SECTION 7

ATR-100

MULTIPOINT SEARCH-TO-CUE ACCESSORY
for ATR-100/MM-1200 Recorder/Reproducers
Operation and Maintenance

ERRATA NO. 2

Figure 7-1. I/O Module

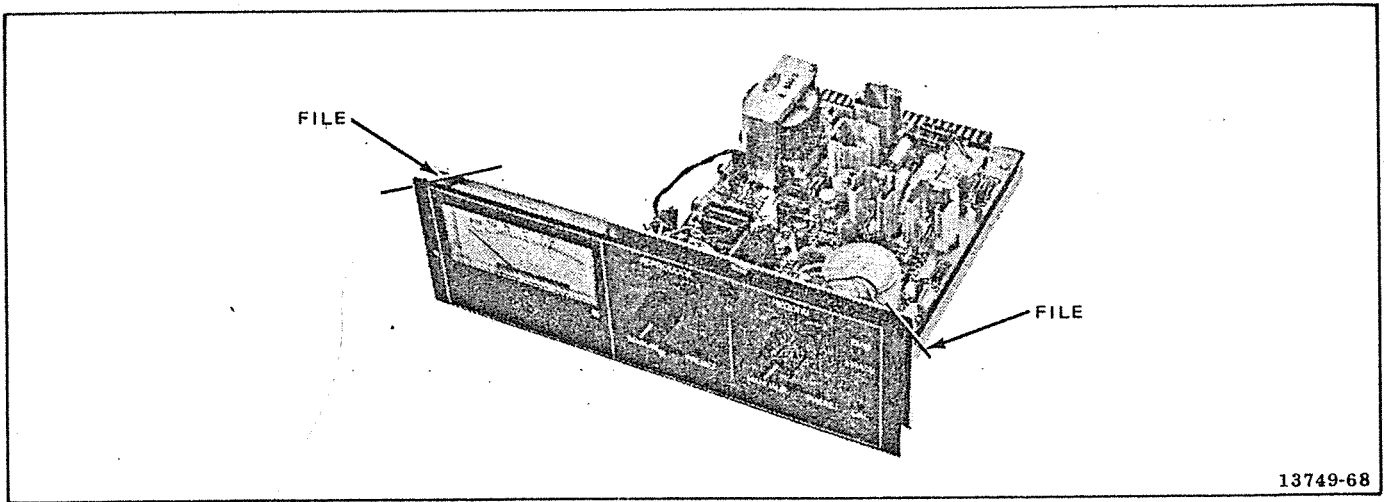
There have been some instances of interference between the I/O module and the main frame casting such as to prevent engagement of the captive holddown screw in the I/O module and the threaded hole in the main frame. This interference is generally caused by the uppermost corners of the I/O module chassis digging into the corners of the main frame. To rectify this problem, use a flat file to produce a 45° chamfer, approximately 3/16-inch long, on the corners of the chassis as shown in Figure 7-1. (Shield critical areas from filings.)

Figure 2-1. Modification to ATR-100 Logic and Tape Timer PWA

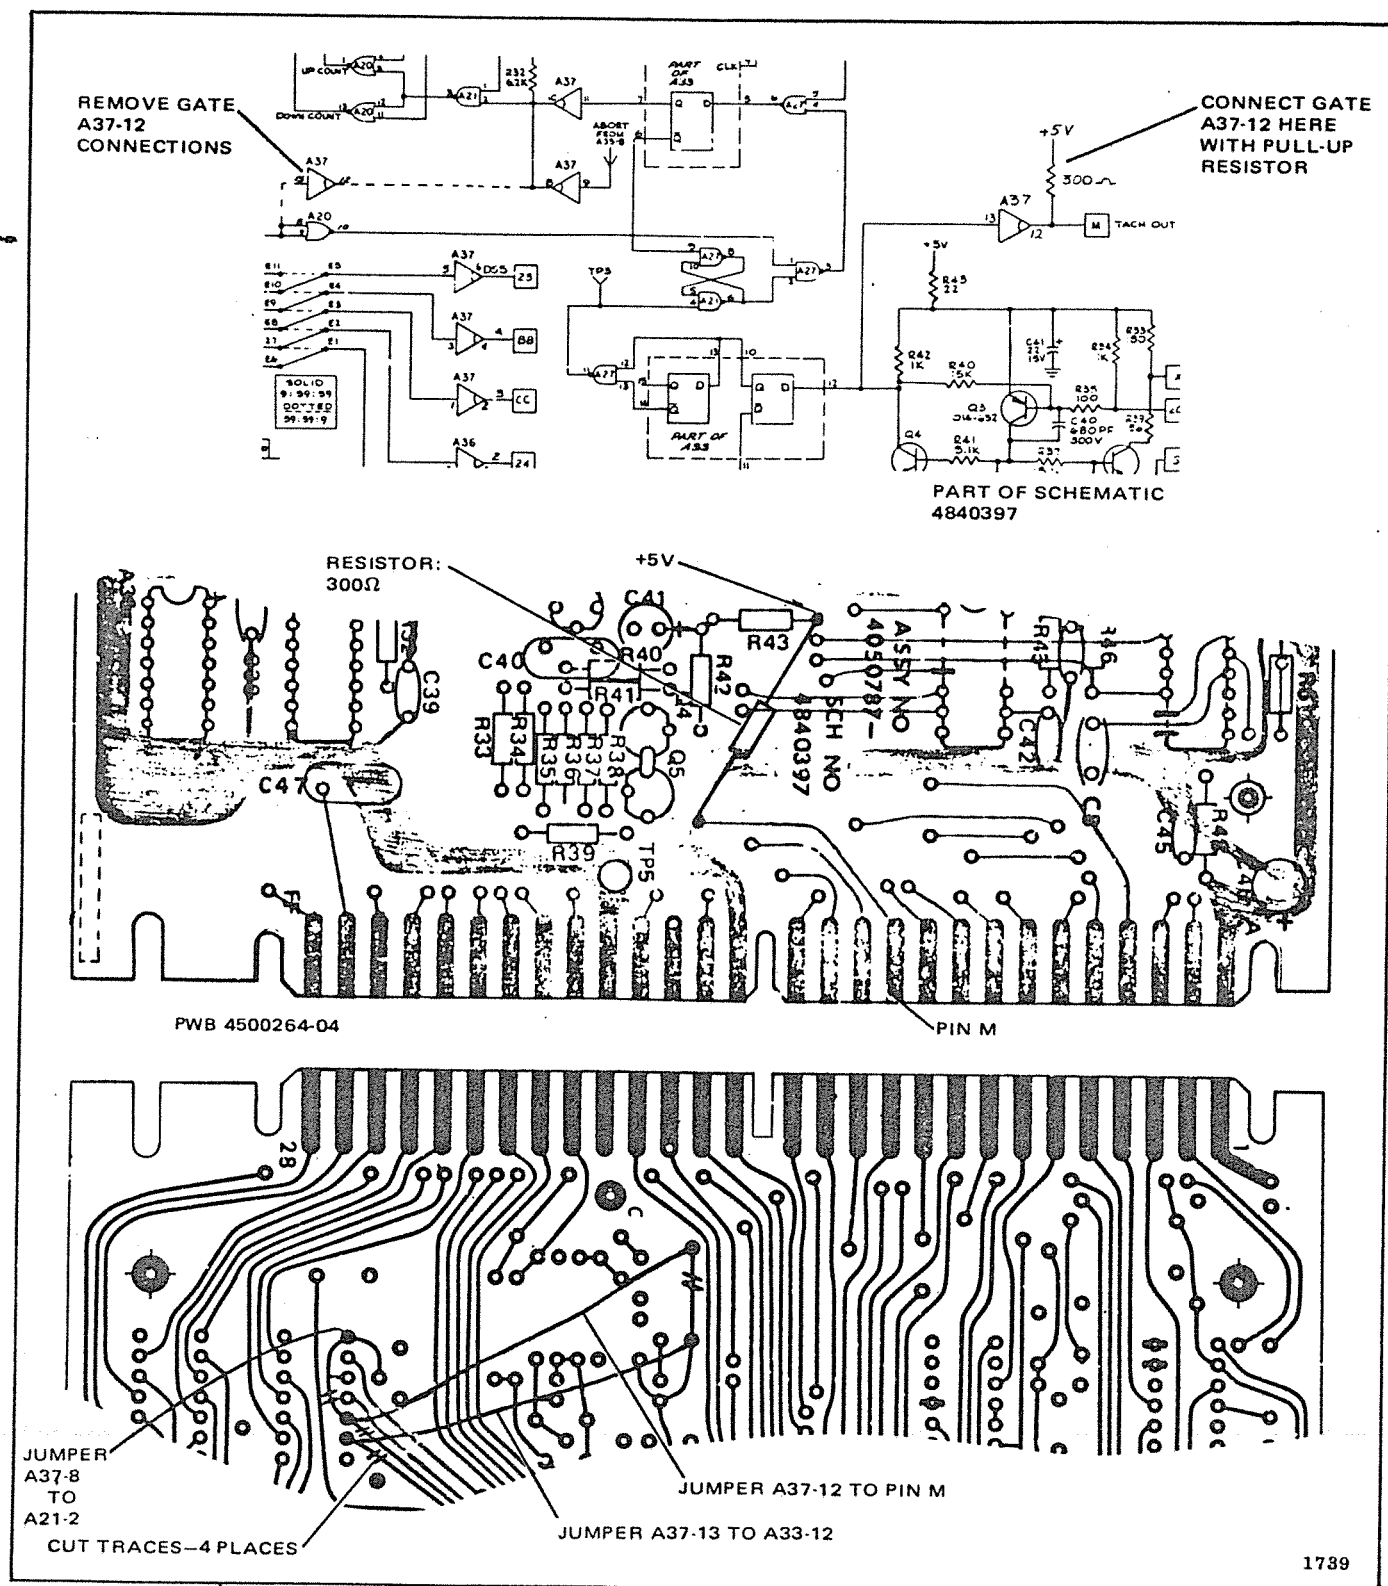
Page 2-2: Delete Figure 2-1.

Page 2-2: Substitute new Figure 2-1, page 2 of this errata.
